SERVICE BULLETIN

REPLACEMENT OF INTERCOM (ICS) SWITCH AND JACK ASSEMBLY

500 Model 369D Helicopters, Serial No. 0003D through 0959D.

Figure 1. Rework of Intercom (ICS) Switch and Jack Assembly into an Adapter Cable

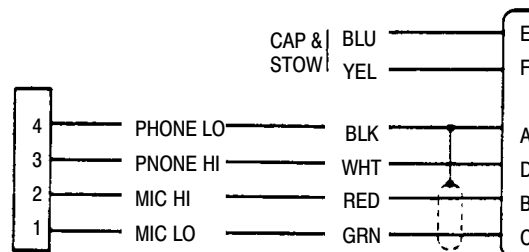
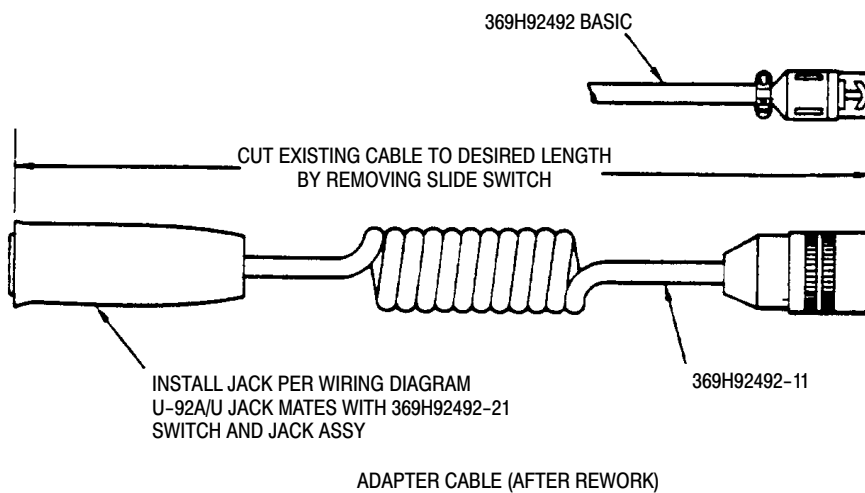
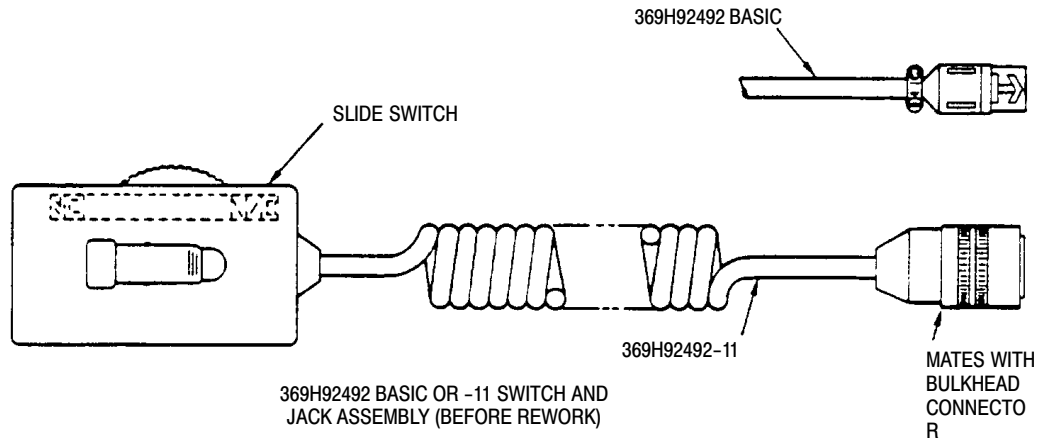
- (3). Rework switch and jack assembly into adapter cable as follows (see Figure 1):
 - (a). Cut cable of switch and jack assembly to desired length and discard switch.
 - (b). Remove insulation from wires in cable and solder wires to new jack. (Refer to appropriate wiring diagram in Figure 1.)
- (4). Connect adapter cable to bulkhead connector in helicopter.
- (5). Connect new switch and jack assembly to adapter cable.
- (6). Connect headphone to new switch and jack assembly.
- (7). Check intercom system (ICS) for proper operation. (Refer to CSP-017.)
- (8). Record compliance with this Service Information Notice in Compliance Record of helicopter Log Book.
